From: Ira Marlowe  
Sent: Fri 2/18/2005 10:37 PM (GMT-05:00)  
To: Mark e. Nikolsky (mnikolsky@mccarter.com)  
Cc: 'Mike Friscia'  
Bcc:  
Subject: Composite to RGB / VGA decoder ICs / changes  
Attachments: ~AUT0006.jpg; ~AUT0005.jpg; ~AUT0004.jpg; ~AUT0003.jpg

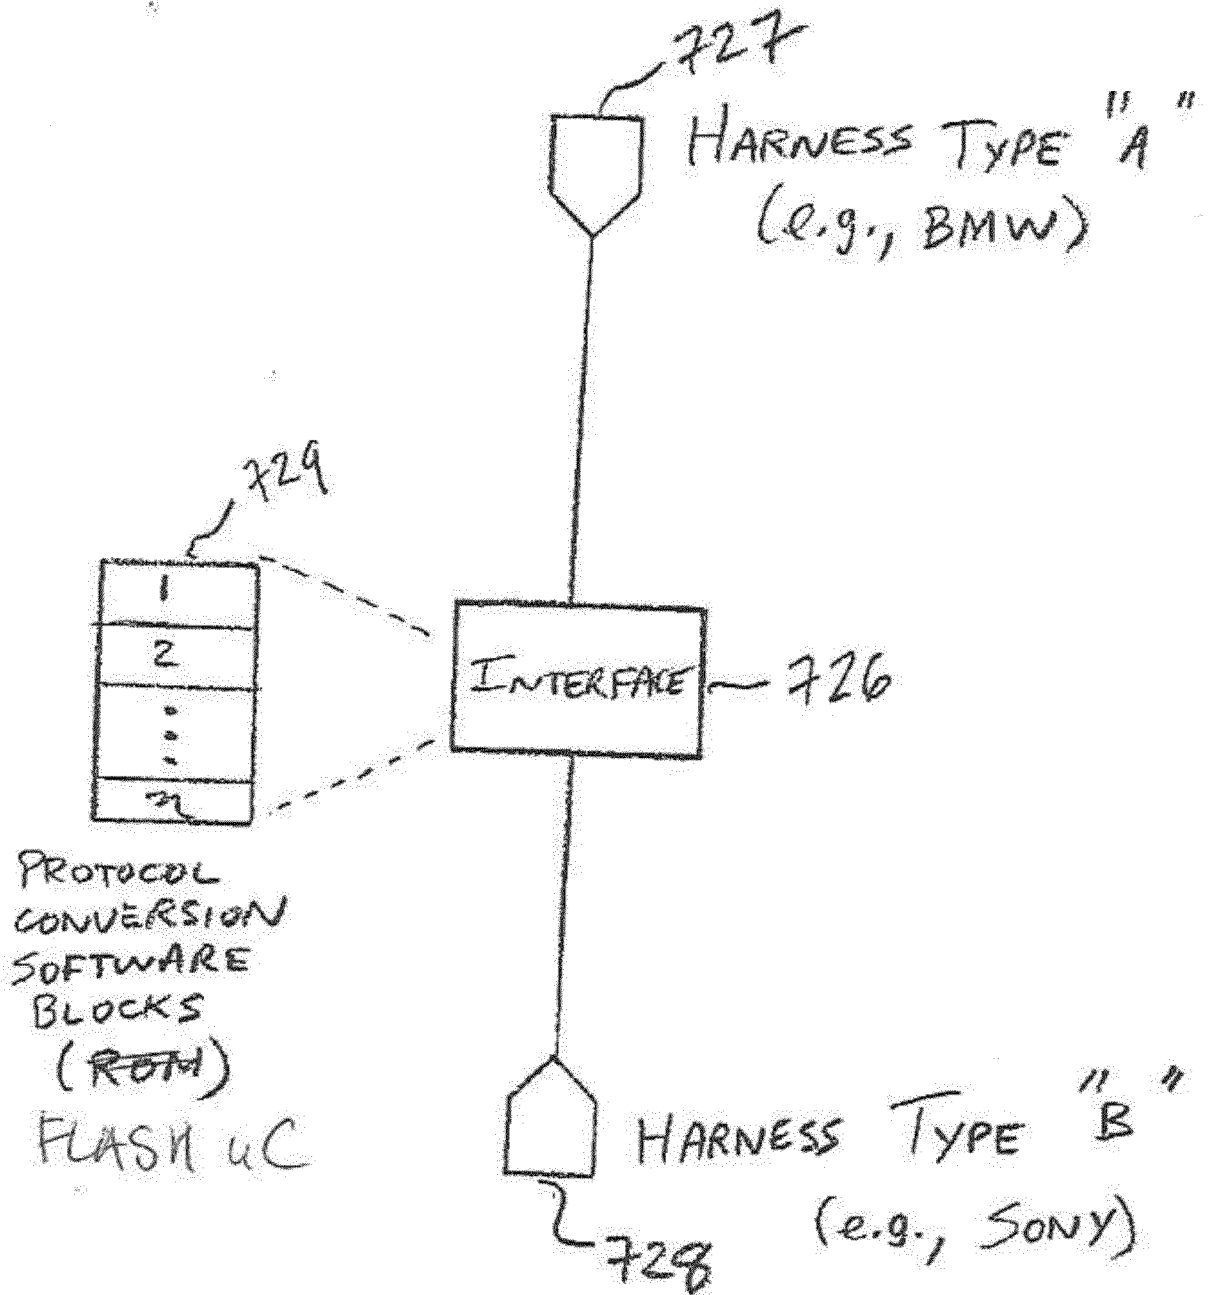
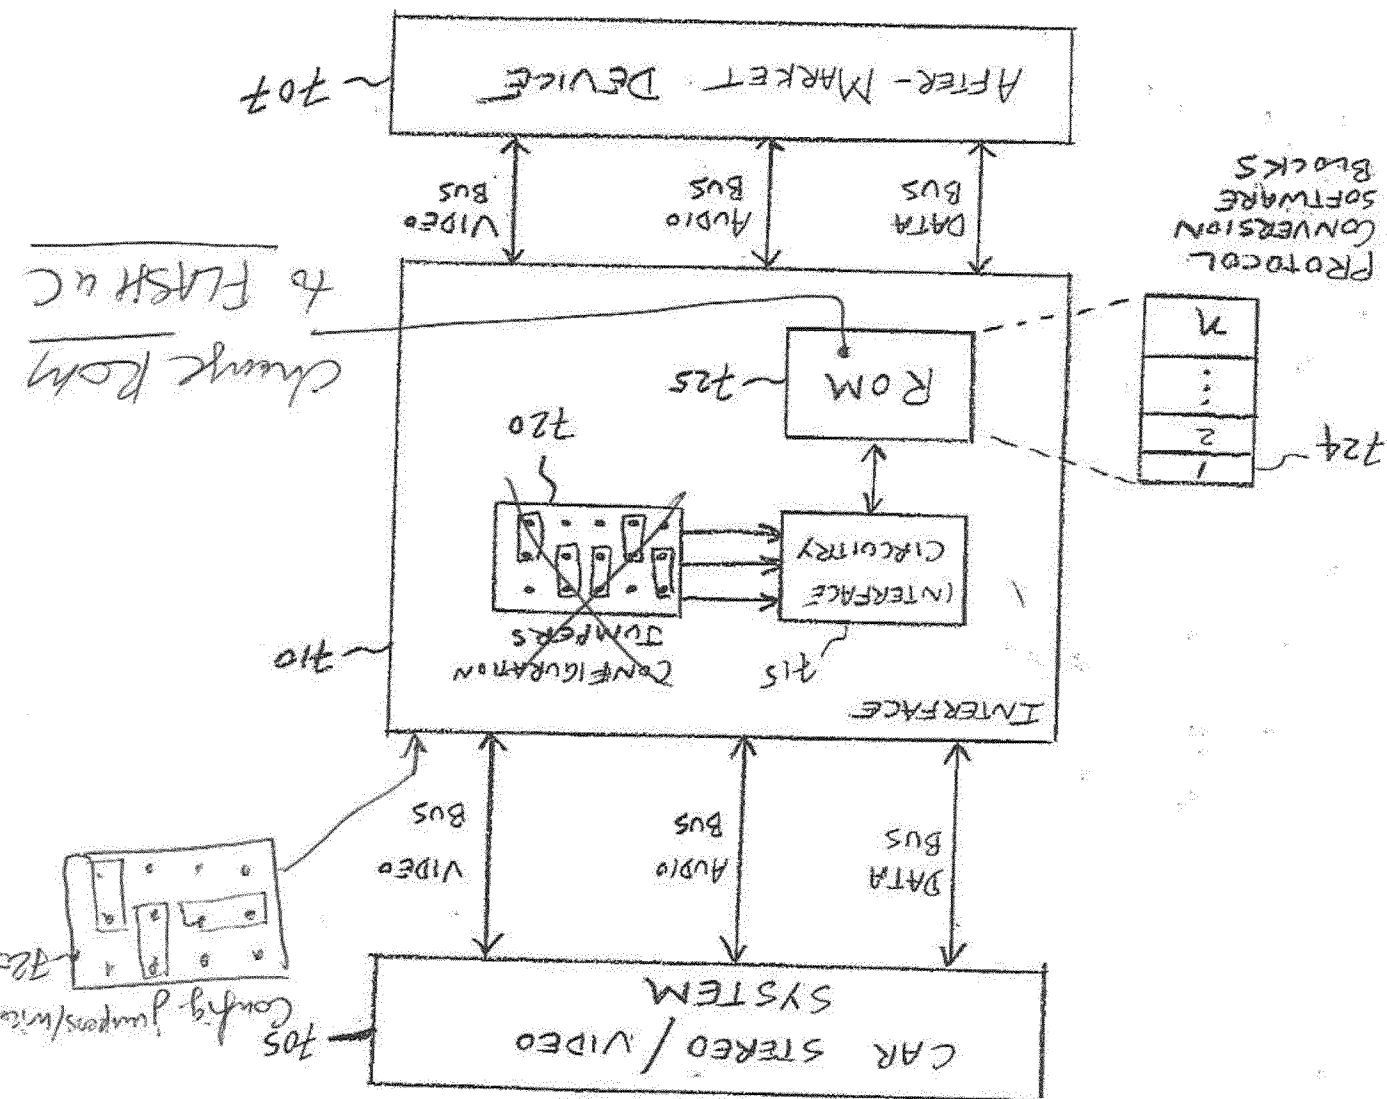
The jumper is not in the interface but in the connector on the wire harness which is plugged into the interface / radio / vehicle bus.

Please correct the drawings enclosed as attachments.
